5315 Elliot Road, Bethesda
[HPC Case # 35/32-13A]
Master Plan Site # 35/32, BATTERY BATTERY
CIVIL WORK CONTRACTORS

SUBJECT: Historic Area Work Permit #658366, installation of ADA ramp and hardscape alterations

MONTGOMERY COUNTY HISTORIC PRESERVATION COMMISSION
STAFF REPORT

PROPOSAL: Installation of ADA ramp and hardscape alterations

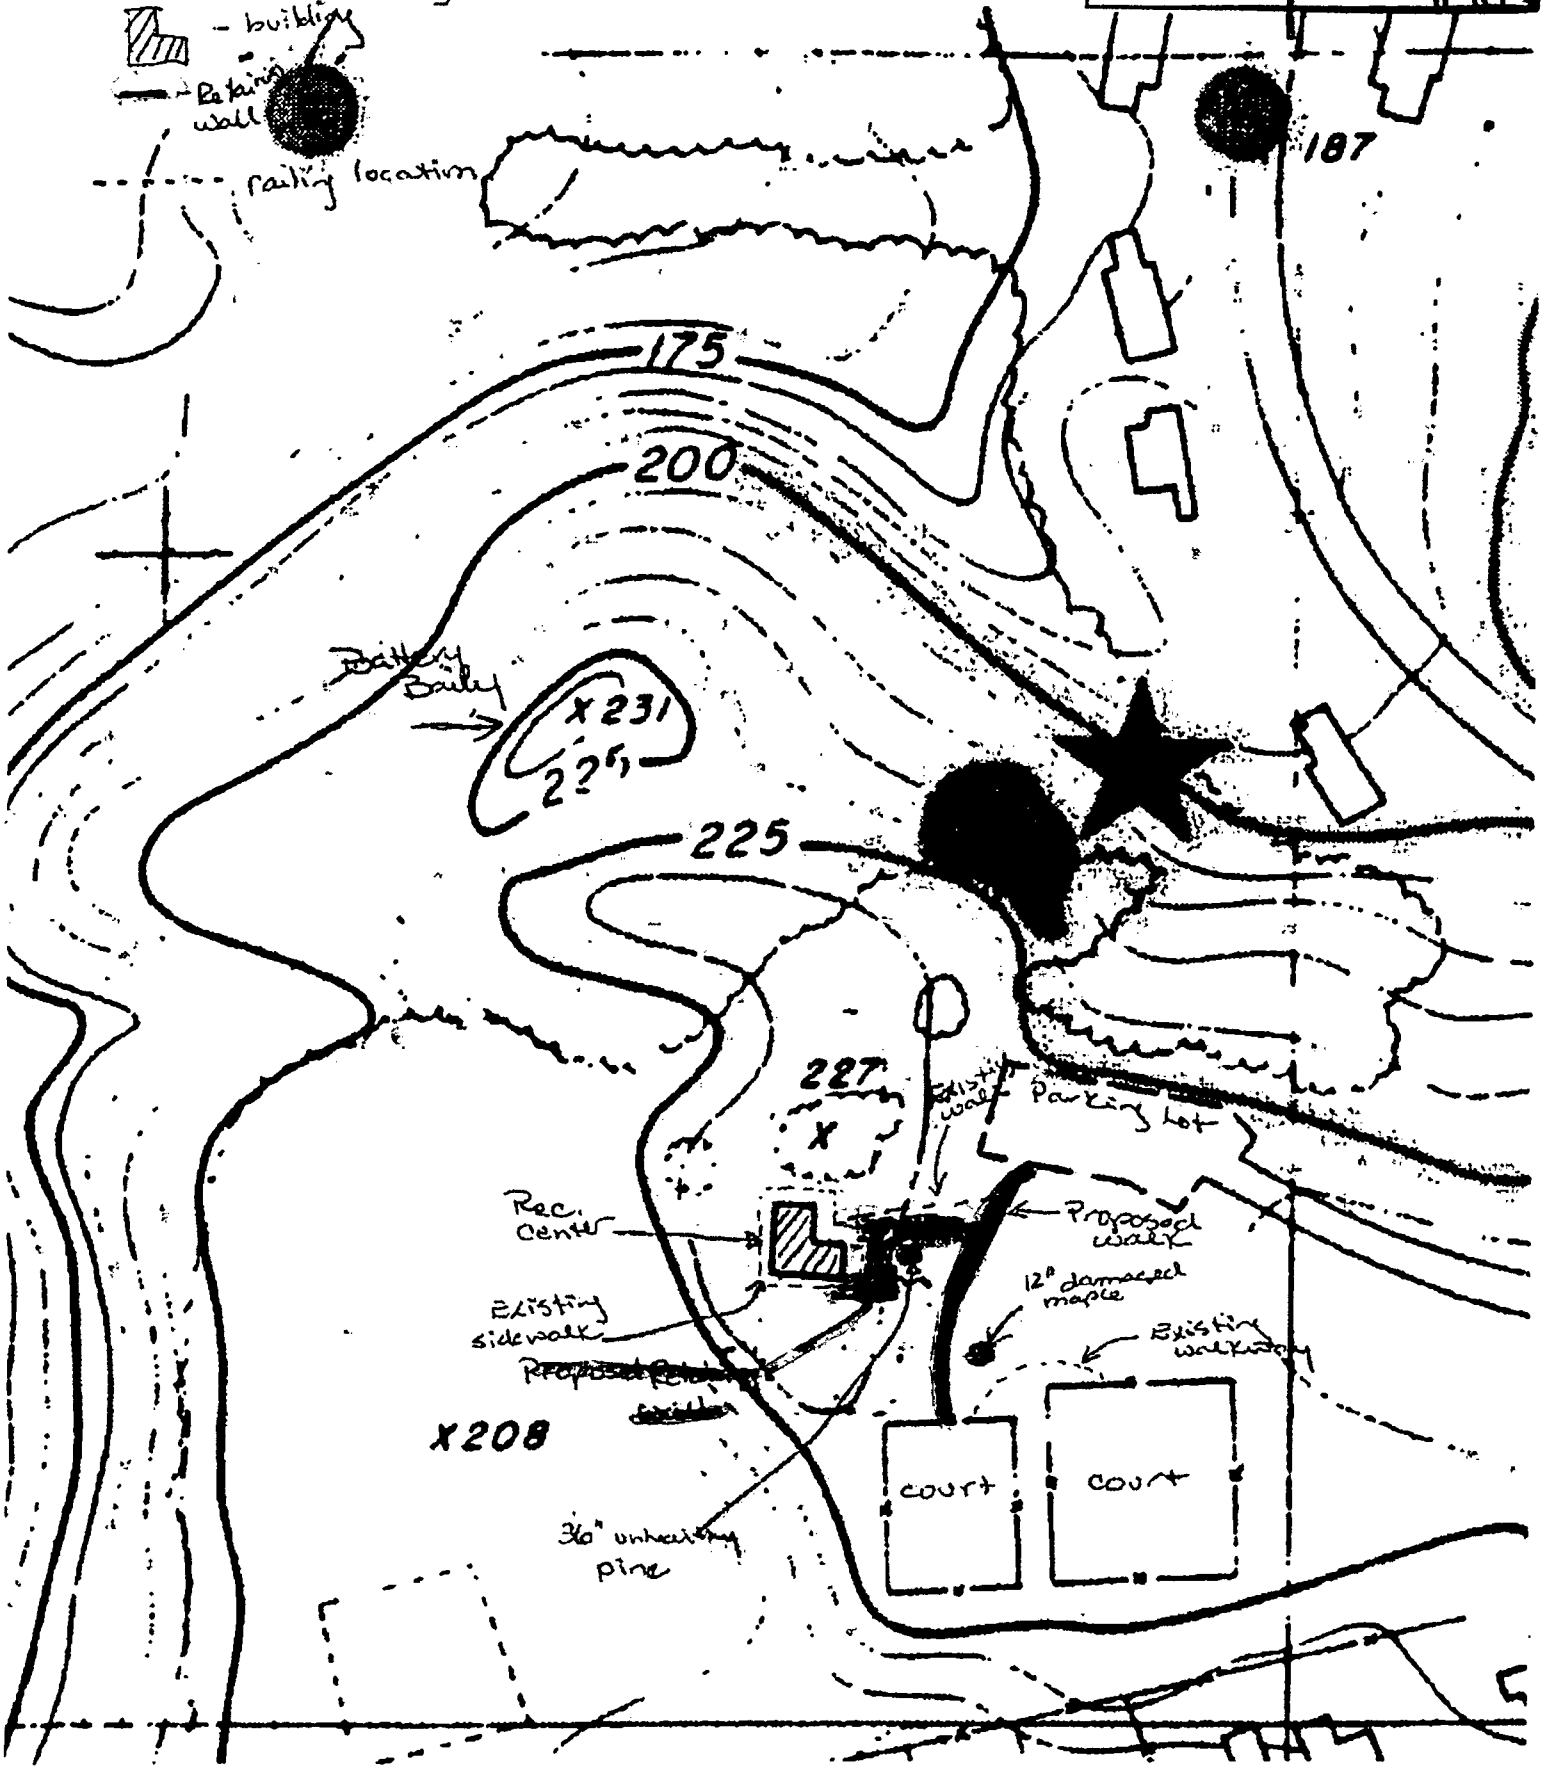
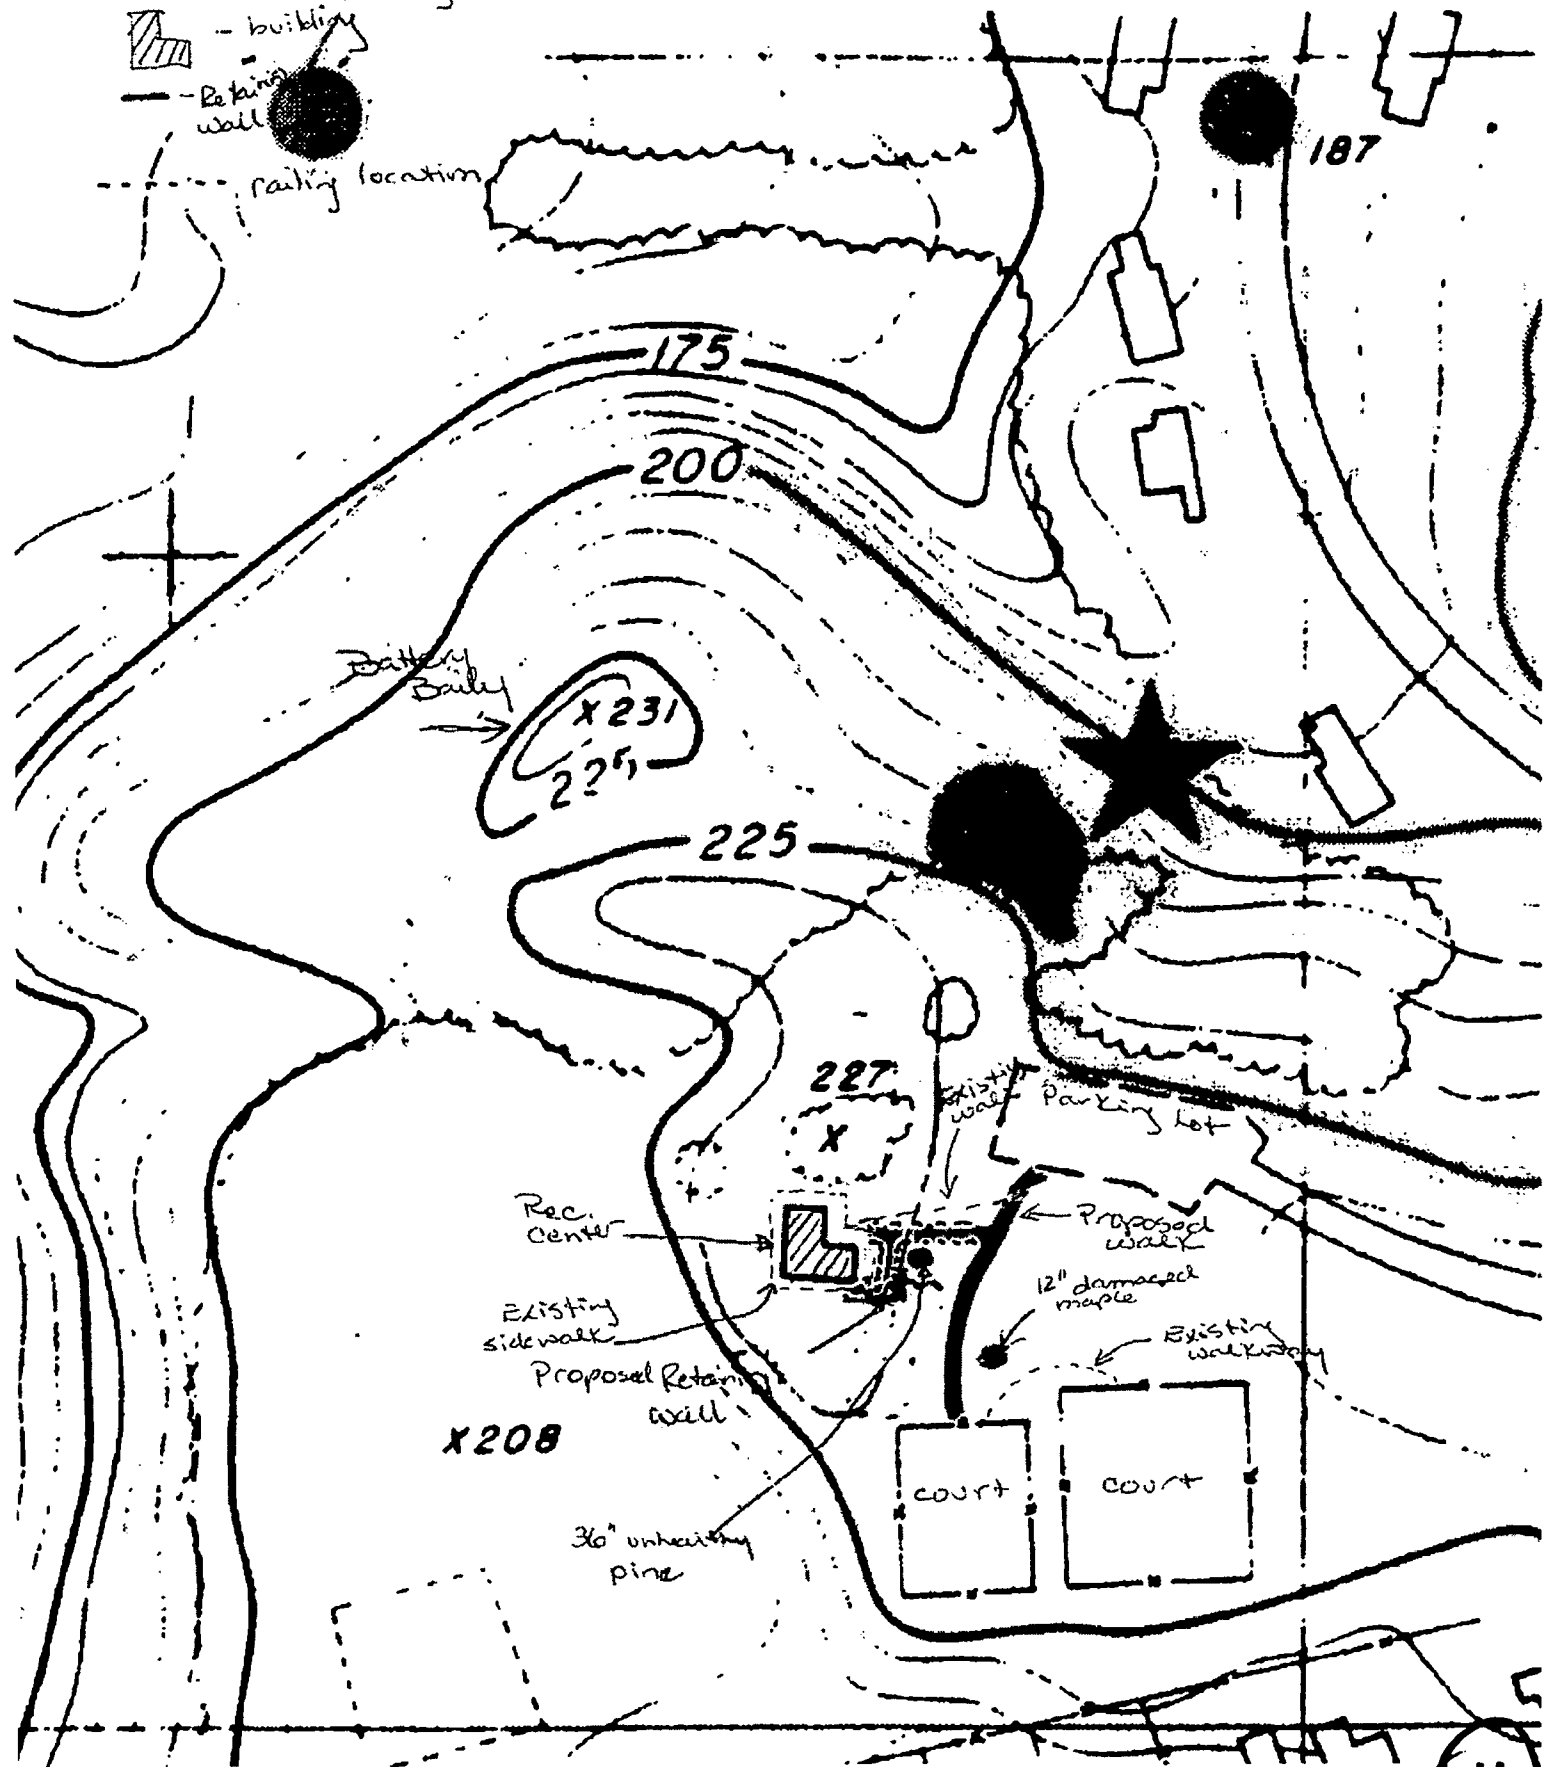
Note: The HPC's preference is to illustrate proposed changes on a site plan. If you have a site plan please mark it up with your changes and e-mail it to me. Was the site plan that I sent to you sufficient?

✓ A detail of the location where the ADA ramp is proposed. Again, I cannot tell from the topo map the location of the ramp and how it connects to the building. It has been confirmed: the ramp is, in fact, a sidewalk that has been graded to meet ADA requirements, allowing a person to travel from the parking lot to the sidewalk that surrounds the building without having to use a frame or metal ramp. The term "ramp", in ADA language, means a walk within a certain slope range. In our case the "ramp" is level with the ground and is not elevated.

✓ The written description states the removal of 95' of an existing 6' wide asphalt path that connects the parking lot to the building, whereas the topo map you provided states "existing walkway". Is this the walkway that is proposed for removal? All of the existing asphalt sidewalk in front of the building will be taken up and replaced by a concrete sidewalk that is one foot narrower than the existing sidewalk. The terms path, sidewalk, and walkway have been used interchangeably in this submittal. I apologize for any confusion. Additional segments of concrete walkway will be added to provide ADA access to the building and other amenities.

- In your e-mail to me yesterday you asked about noting trees on the plan. I see two trees indicated on the plan. Are you proposing to remove these trees? If so, please provide their species and size. The site plan that I sent you notes all of the trees in the immediate vicinity of the proposed project. In an earlier email, I stated that no trees were expected to be removed. However, this afternoon, it was confirmed by our Horticulture Division that, in fact, the two trees that I noted in the submittal will have to be removed. 1) The inside of the 12" Red Maple (*acer rubrum*) is decaying. We need to take this tree down even if the path were not constructed as it is in danger of falling. 2) The 36" white pine (*pinus strobus*) is in fair condition, but will not survive the grading required to meet ADA standards. The route of the sidewalk was placed near this tree to avoid other healthier ones.

<p>PARK DEVELOPMENT DIVISION</p> <p>9500 BRUNETT AVENUE SILVER SPRING, MD 20901</p>	<p>_____ PARK DEVELOPMENT DIVISION CHIEF</p> <p>_____ DATE APPROVED</p>	<p>ADA HANDRAIL - RAMP</p>

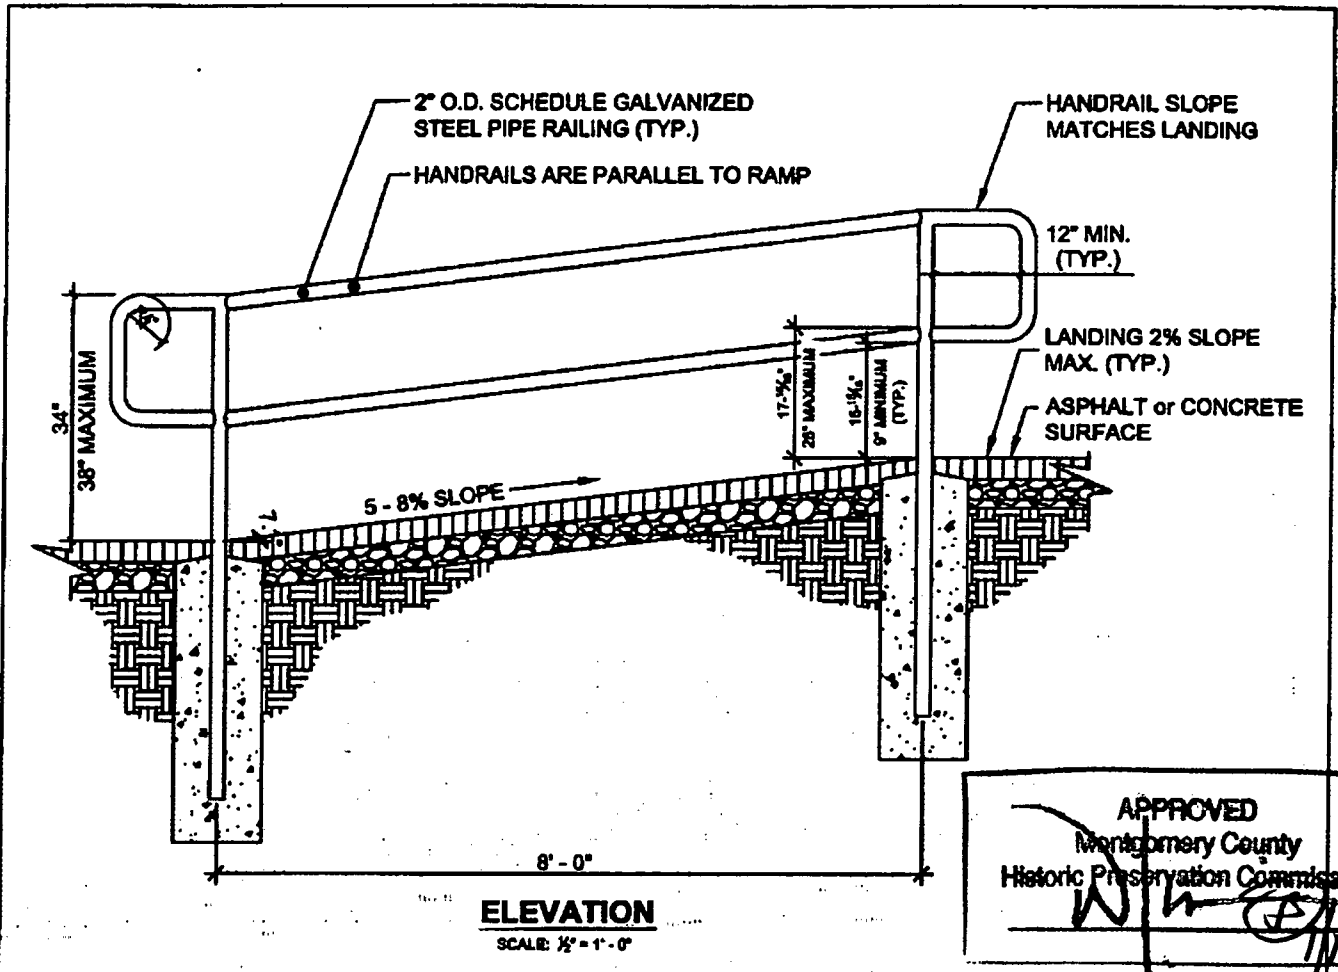
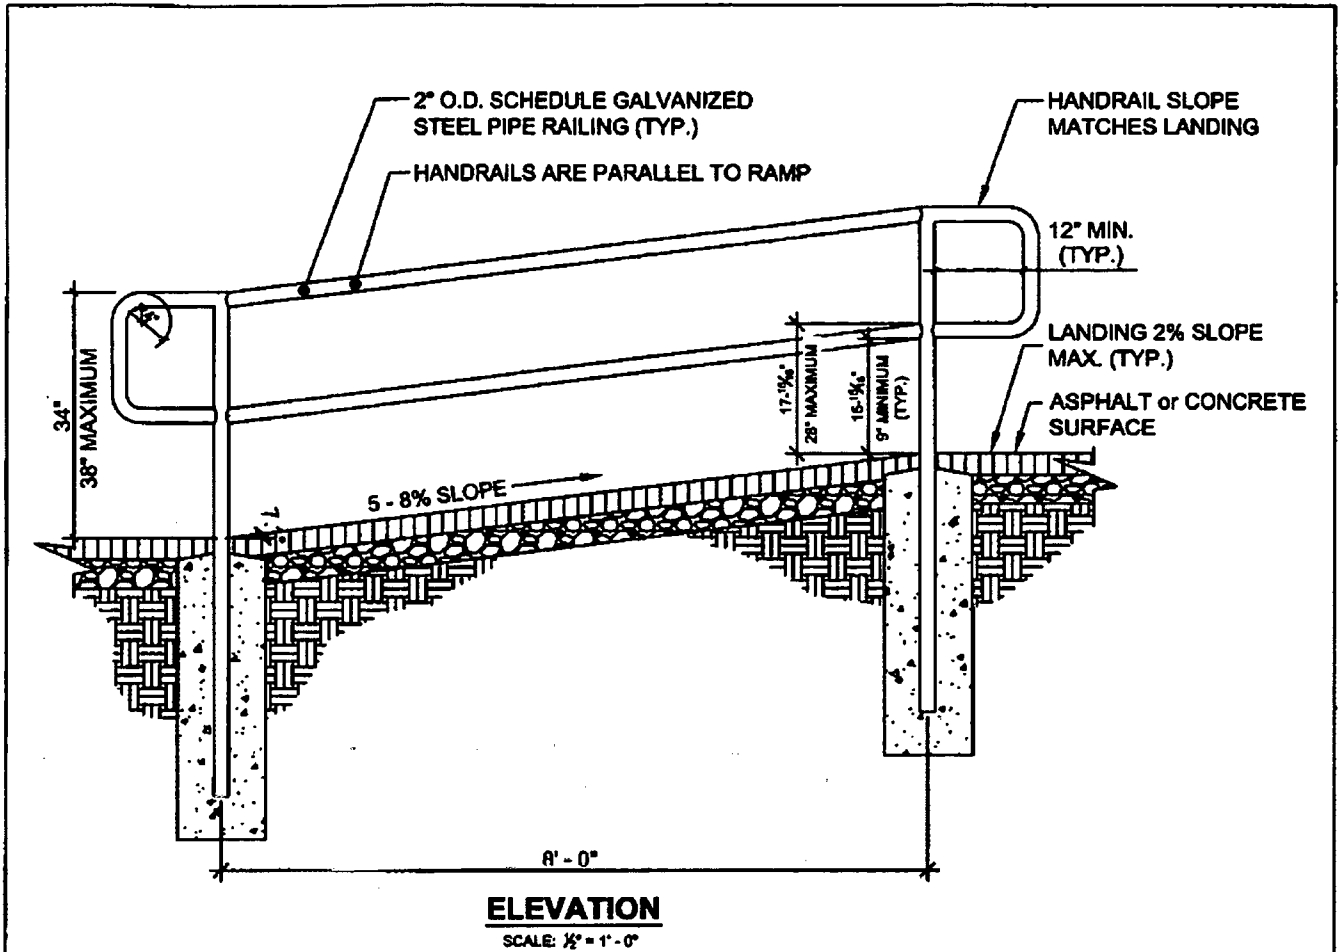
✓ The locations and style of the handrail (Item 1.c.). I suggest you provide a detail for the handrail locations. I cannot tell from the topo map where the hand railings start/stop on the proposed new pathway. The handrail is indicated somewhat inexactly on the drawing that I sent you with a dotted black line. If you look at the pink proposed walkway, the railing will be attached to the concrete walk starting where the walk juts off from the path leading down to the ball courts. The railing continues along the walkway until it connects to the sidewalk that surrounds the building. I can't tell if this is indicated on the site plan that I emailed today, but I don't think it is. Please keep in mind that the community center is not a historic resource. The railing locations are on the site plan, but it may be difficult to read.
